STATE OF MICHIGAN
DEPARTMENT OF ENVIRONMENTAL QUALITY
JACKSON DISTRICT OFFICE

June 23, 2008

SUBJECT: Gelman Sciences, Inc. Remedial Action

Valley Report and AE-3 Analysis

Gelman Science Selected Wells and Borings
Figure 1
Washtenaw County
June 2008

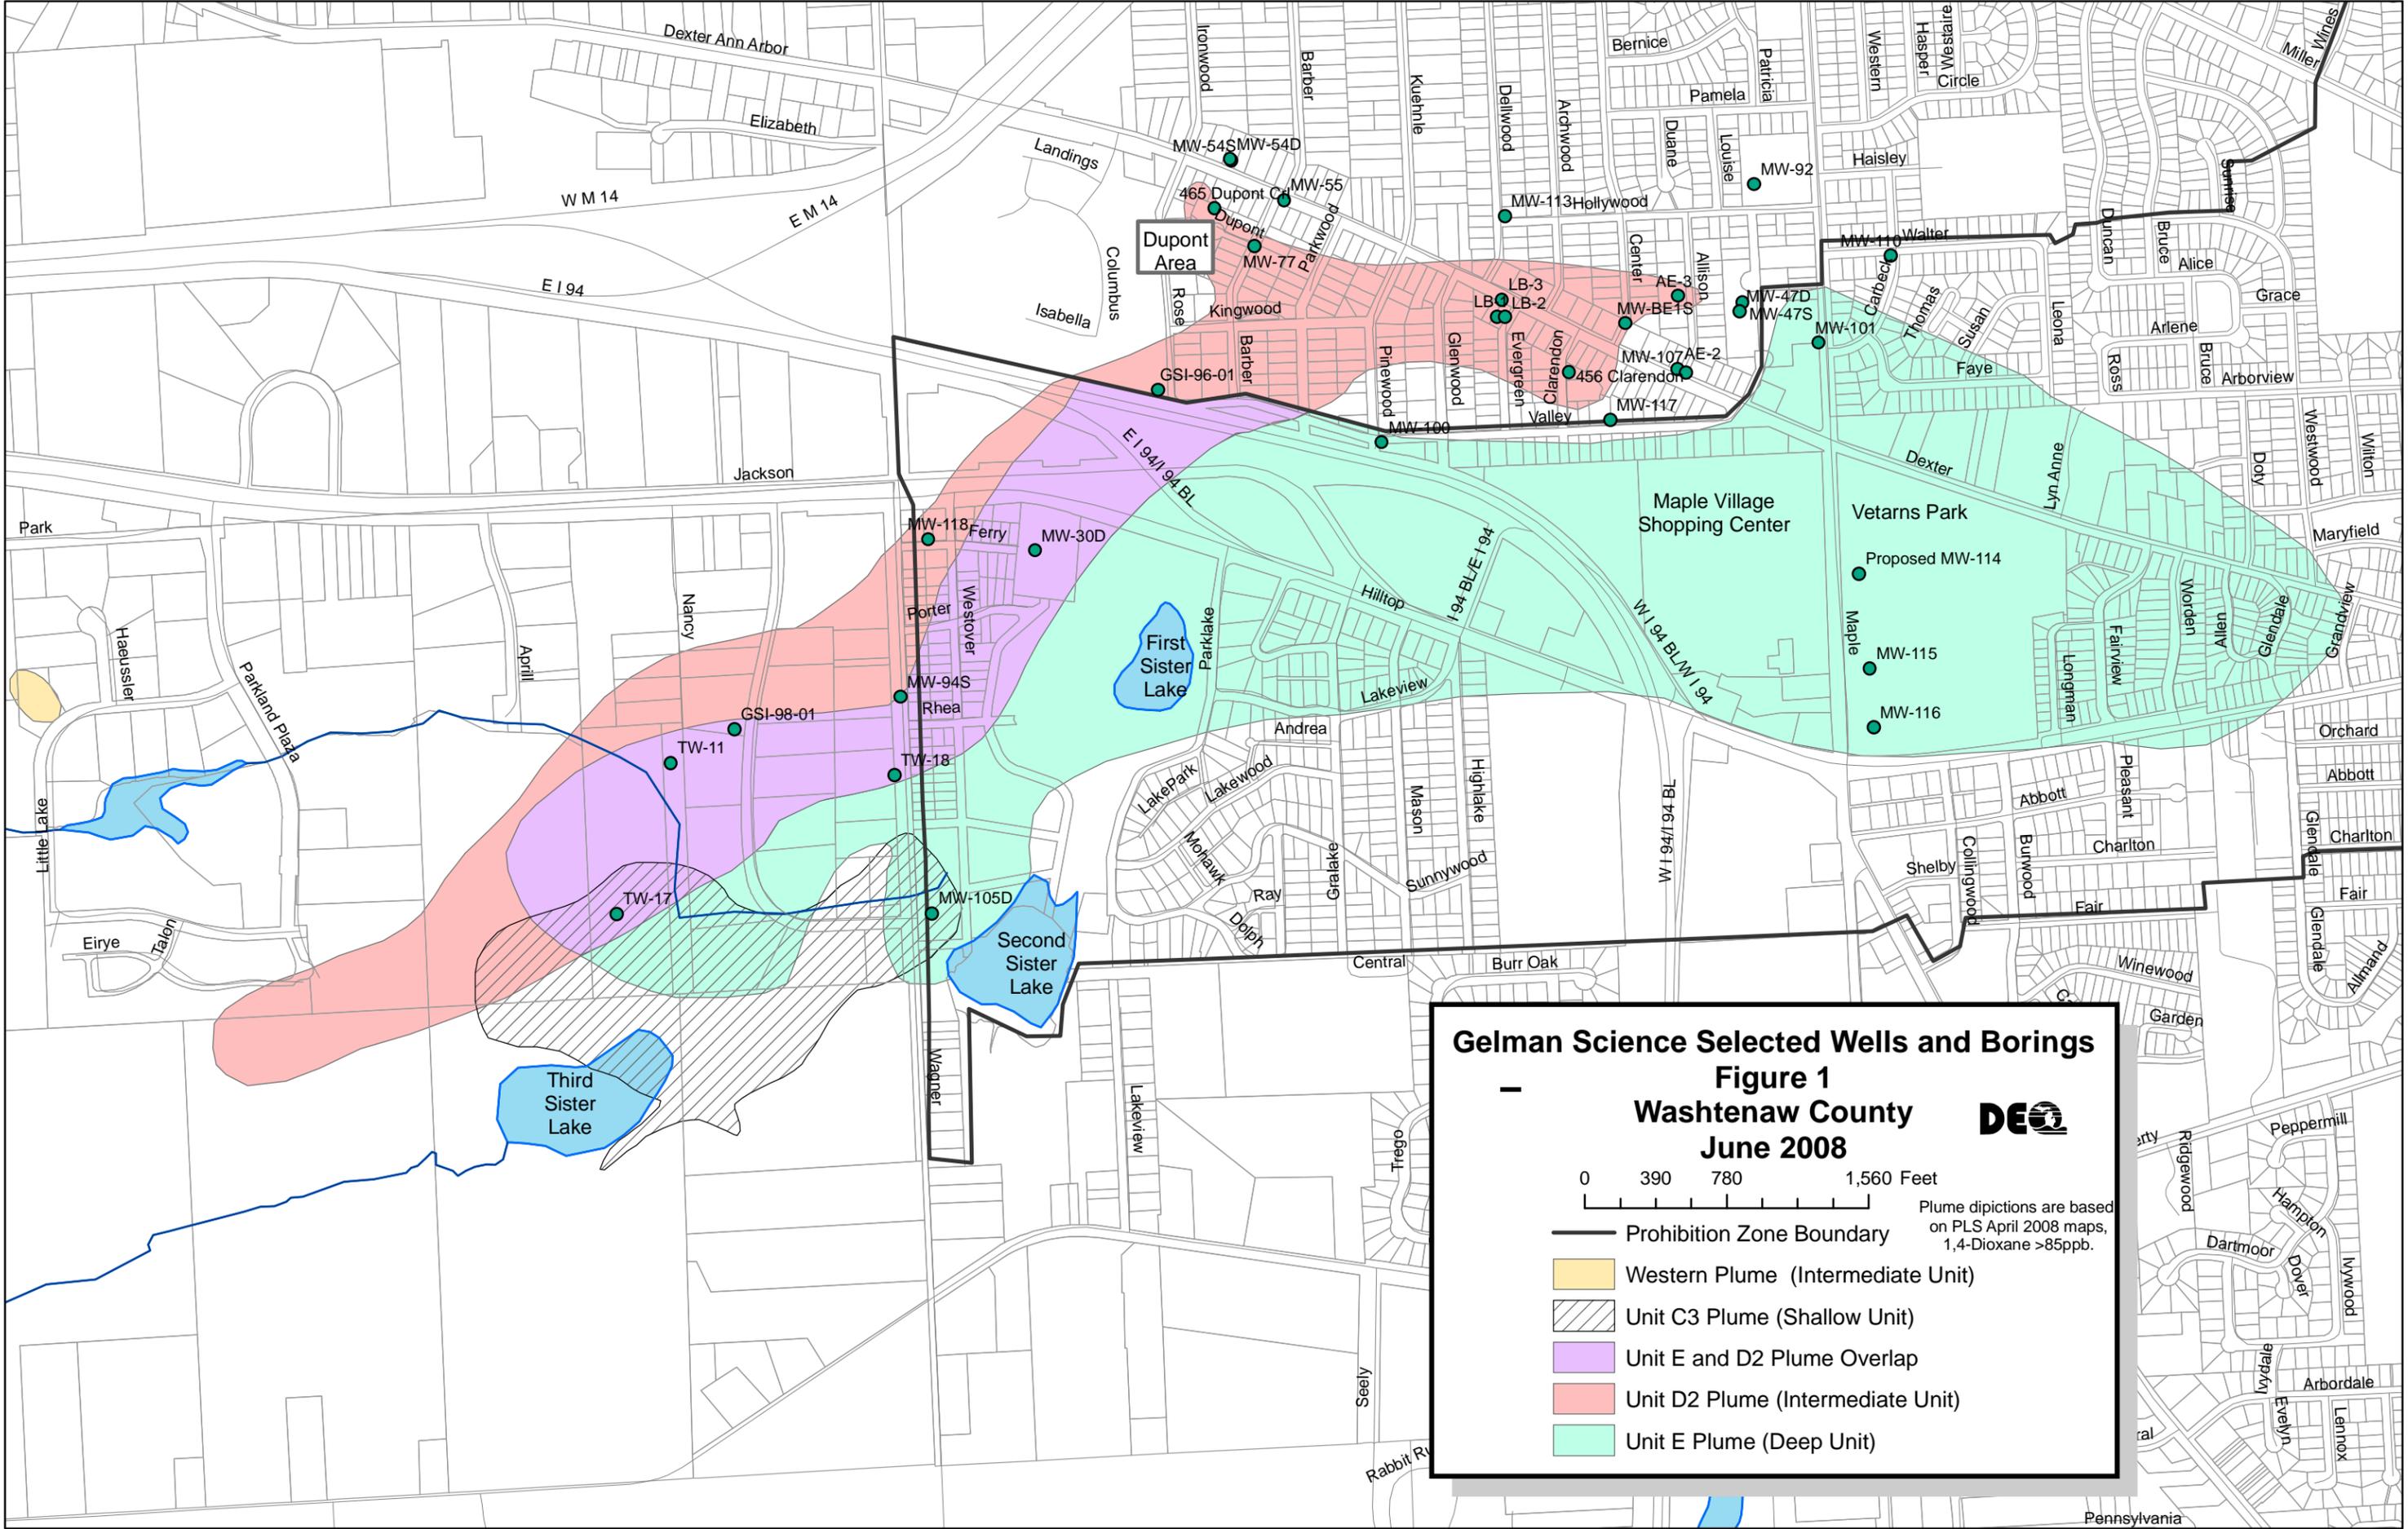
The primary purpose of this letter is to provide the Department of Environmental Quality's (DEQ) response to three recent reports submitted by Pall Life Sciences (PLS) related to the Evergreen System, as referenced below. This letter also summarizes the DEQ's position on several other issues that need to be resolved in a timely manner. The enclosed Figure 1 is provided for reference to many of the wells and locations discussed in this letter and the enclosed interoffice communications.

As discussed by Mr. Mandle, the DEQ does not believe the existing extraction wells (LB-1, LB-3 and AE-3) are capturing all of the groundwater contamination migrating toward them. However, the DEQ recognizes that the existing dataset is not conclusive, in part because the entire vertical and horizontal extent of groundwater contamination that must be captured is not defined. Therefore, the DEQ is unable to determine if PLS is in compliance with Section V.A.1.(a) of the Consent Judgment, to intercept and contain the leading edge of groundwater contamination in the Evergreen Subdivision Area.

An additional area of concern, not addressed by the Stipulation, is the 1,4-dioxane contamination at MW-100, a Prohibition Zone (PZ) monitoring well adjacent to the Evergreen Subdivision Area on Valley Drive. MW-100 has been above 85 ppb since September 2007, and was 168 ppb in May 2008. The DEQ does not understand PLS's current depiction of the Unit E plume at the PZ Boundary (based on data through March 2008), which indicates that concentrations of 1,4-dioxane as high as 500 ppb are at the PZ boundary at Valley Drive, but does not depict any Unit E groundwater contamination in the Evergreen Subdivision Area. This representation implies that there is an impermeable wall at the PZ boundary and does not correspond to PLS's discussion of the source of groundwater contamination in the Dupont area, as discussed in the next section of this letter. Although there are no data points to confirm that groundwater contamination at MW-100 has migrated into the Evergreen Subdivision Area, the DEQ believes that it has, and that PLS must address it as part of its obligation to meet the objectives in the Consent Judgment for the Evergreen Subdivision Area. The Valley Report does not address the groundwater contamination at MW-100, nor has PLS indicated that the Evergreen System extraction wells have had any influence on groundwater in the area of MW-100.

It is more appropriate to consider water quality data from the TW-11 boring (about 375 feet southwest of GSI-98-01) to evaluate the possibility that a plume could be migrating from the area near the south end of Nancy Drive toward the Dupont area. First, high concentrations of 1,4-dioxane (3,100 ppb) were found during the boring of TW-11 in December 2001, at a depth similar to the well at 465 Dupont Circle. As noted by Mr. Cogger, Figure 8 of the Dupont Report indicates groundwater flow in the TW-11 area is from the southwest to the northeast, in the direction of the Dupont area. The only boring between TW-11 and MW-118, a distance of 1,800 feet, is GSI-98-01, where PLS has indicated that attempts to collect water quality data were unsuccessful. There is no basis for PLS to assert that the information gathered during the drilling of MW-118 demonstrates that there is no groundwater contamination migrating from the area around Nancy Drive toward the Dupont area. Inadequate data have been presented to conclude that contamination in the Nancy Drive area is not the source of contamination in the Dupont area.

Second, trend analysis data indicate that the source of 1,4-dioxane in the Dupont area is more likely from the area around TW-11, rather than from the area around MW-30d. MW-30d is 2,100 feet southwest of the well at 465 Dupont Circle. If 1,4-dioxane at MW-30d is the source of 1,4-dioxane at 465 Dupont Circle, then 1,4-dioxane should have impacted MW-30d before it reached 465 Dupont Circle. This is not the case. In April 1999, 1,4-dioxane greater than 85 ppb was first found at 465 Dupont Circle, three years before that concentration was found at MW-30d. The concentration of 1,4-dioxane near TW-11 in 2001 (3,100 ppb) would indicate that it was likely much higher than 85 ppb before 1999, and could be a source of 1,4-dioxane at 465 Dupont Circle.

1. Fully define the extent of groundwater contamination in the Evergreen Subdivision Area and determine if the leading edge of groundwater contamination detected in the vicinity of the Evergreen Subdivision Area, including the groundwater contamination in the Dupont Circle area and in the area of MW-100, is being intercepted and contained, and take additional remedial actions to do so, if necessary;
2. Define the nature and extent of groundwater contamination west of Wagner Road;
3. Achieve capture of all groundwater contamination at Wagner Road or provide a demonstration that it is not feasible to do so;
4. Install the third performance monitoring well in Veterans Park
5. Provide an analysis of PLS's operational decisions in all future Quarterly Reports.
